11-4-2020 - (R2) - R2 UPDATES:

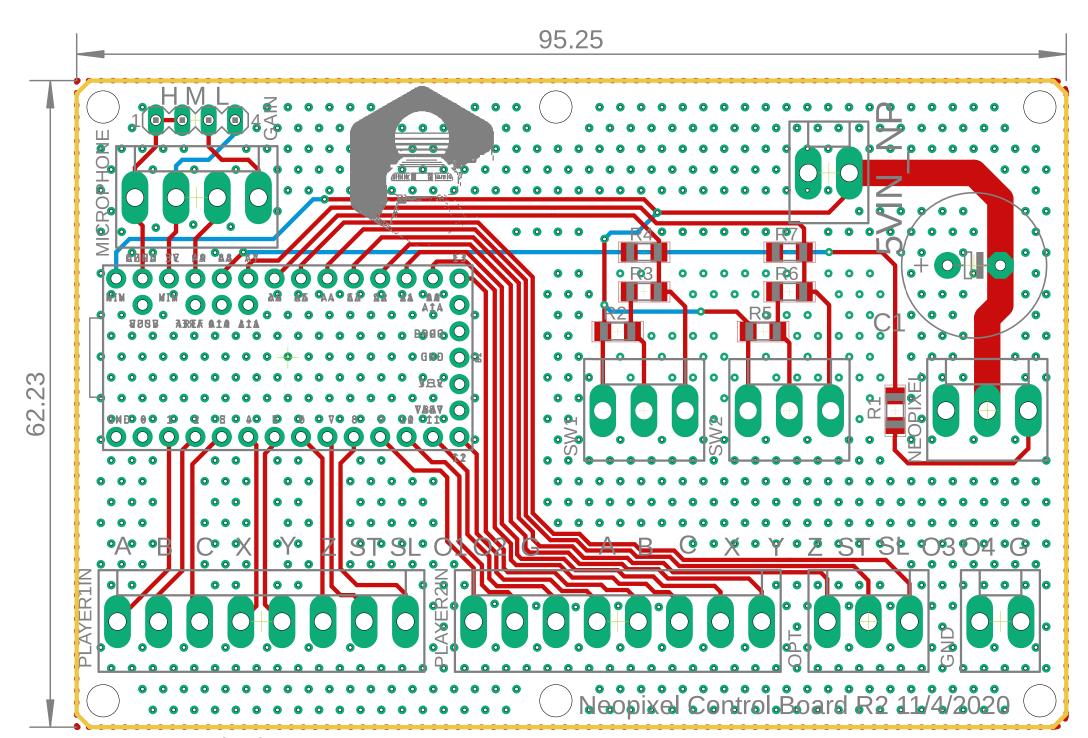
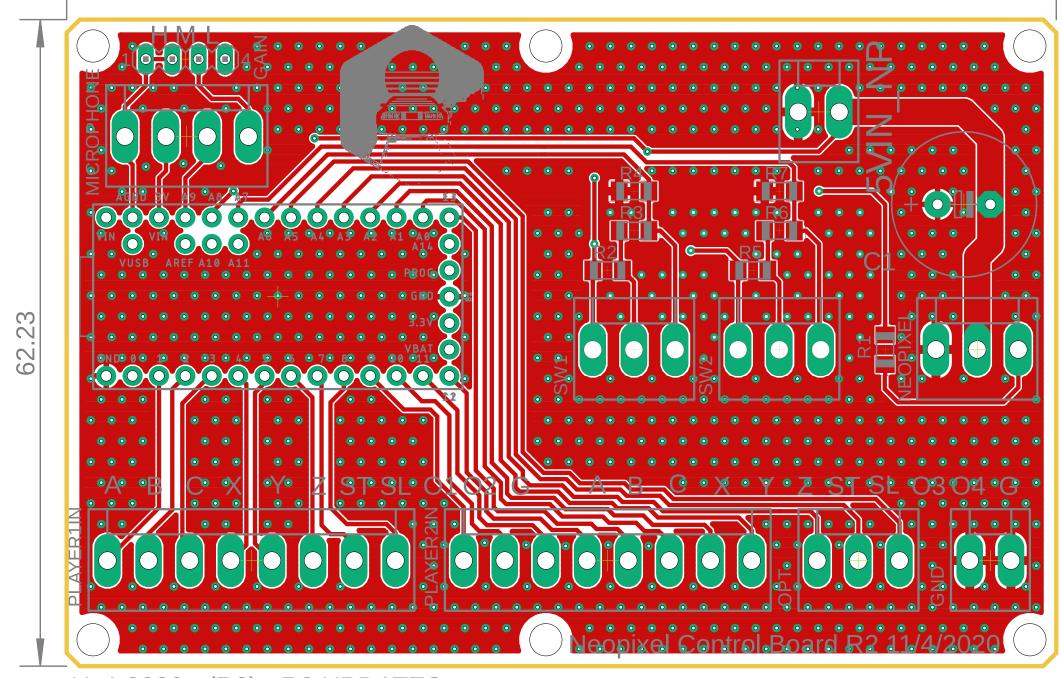
- 11-4-2020 (R2) R2 UPDATES:
- 1. MOVED ALL CONTROLS UP ONE PIN ON TEENSY (D0 WOULD NOT REGISTER A ON P1).
- 2. REMOVED OPT4 AS IT IS NOT USED IN THE DESIGN
- 3. SWAPPED 2X 11 PIN MOLEX HEADERS FOR 2X 8 PIN (P1 AND P2), 1X 3 PIN (OPT) AND 1X 2 PIN (GND) TO BETTER SPLIT THE GROUPS OF INPUTS
- 4. REMOVED THE 3 PIN 5VIN MOLEX CONNECTOR AND CONSOLIDATED 5VIN TO AN 2 PIN CONNECTOR (FORMERLY 5VINNP)

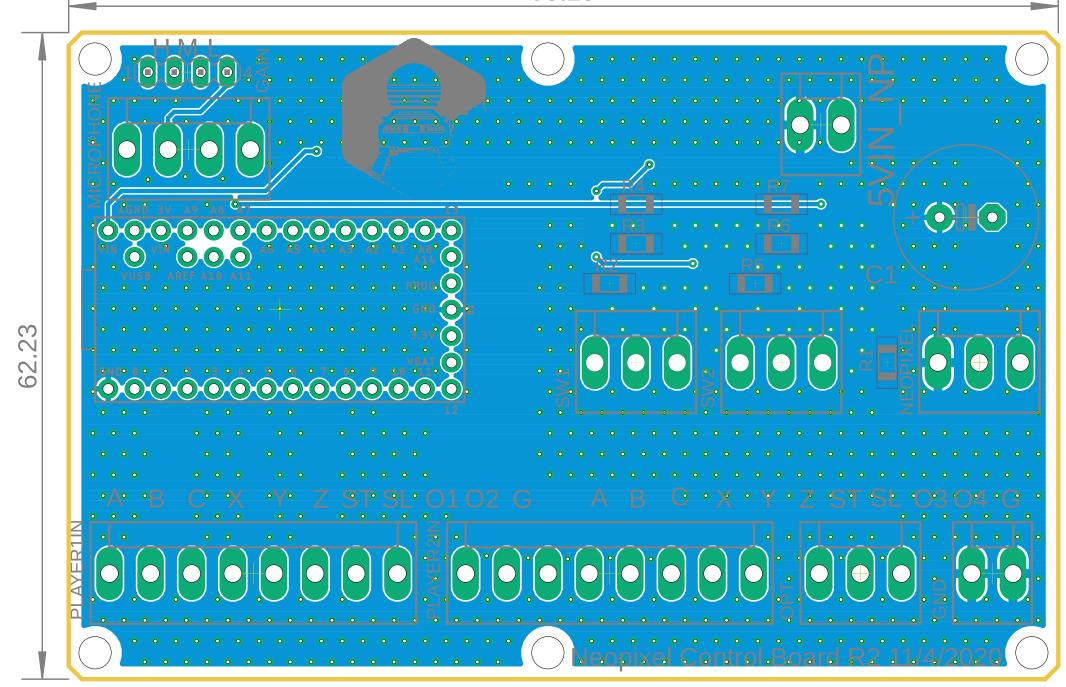
- 1. MOVED ALL CONTROLS UP ONE PIN ON TEENSY (D0 WOULD NOT REGISTER A ON P1).
- 2. REMOVED OPT4 AS IT IS NOT USED IN THE DESIGN
- 3. SWAPPED 2X 11 PIN MOLEX HEADERS FOR 2X 8 PIN (P1 AND P2), 1X 3 PIN (OPT) AND 1X 2 PIN (GND) TO BETTER SPLIT THE GROUPS OF INPUTS
- 4. REMOVED THE 3 PIN 5VIN MOLEX CONNECTOR AND CONSOLIDATED 5VIN TO AN 2 PIN CONNECTOR (FORMERLY 5VINNP)
- 5. ALL INPUT TRACES RERUN, STICHING RERUN TO MATCH NEW TRACES
